# Wellington to Hutt Valley Walking and Cycling Path – Petone to Melling

Preliminary Design Stage

**Safety Audit Report**

**Date:** June 2017

2.4.12. Both routes – Bridge Street

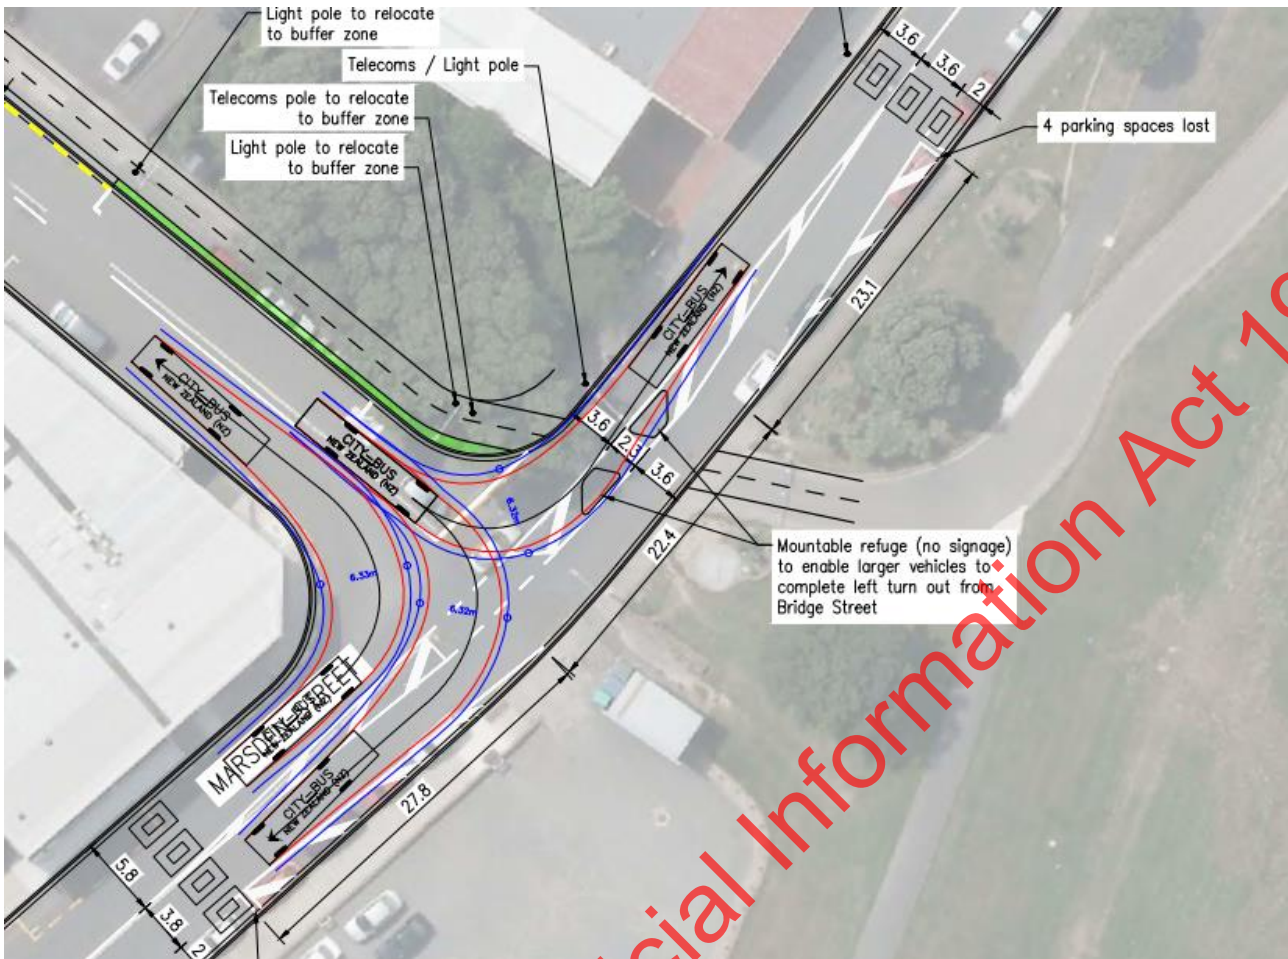
The proposed detail for Bridge Street between Normandale Road and Marsden Street is shown below.

No detail is provided of the treatment of the accesses. The accesses appeared well used during the brief site visit undertaken. Parking and fences on the boundary and parking on the road will limit visibility of vehicles to path users and vice-versa.

Provide physical separation of properties from path away from accesses to minimise vehicle manoeuvring on the shared path and improve visibility.

Provide appropriate treatment of the vehicle accesses to slow vehicles down and warn path users and cyclists of potential conflicts. Consider work undertaken by Wellington City Council on treatment of accesses on Hutt Road and other national best-practice guidance.

<b>Frequency Rating:</b> <i>Crashes are likely to be</i> <b>Common</b>	<b>Severity Rating:</b> <i>Death or serious injury is</i> <b>Likely</b>
<i>Designer Response: Current-practice treatments will be provided at vehicle crossings. Discussions will be held with HCC to see if parking can be removed from the other side of Bridge Street in this location to create additional width to minimise the conflict with exiting vehicles that cross the shared path.</i>	
<b>Safety Engineer:</b>	Click here to enter text.
<b>Client Decision:</b>	Click here to enter text.
<b>Action Taken:</b>	Click here to enter text.
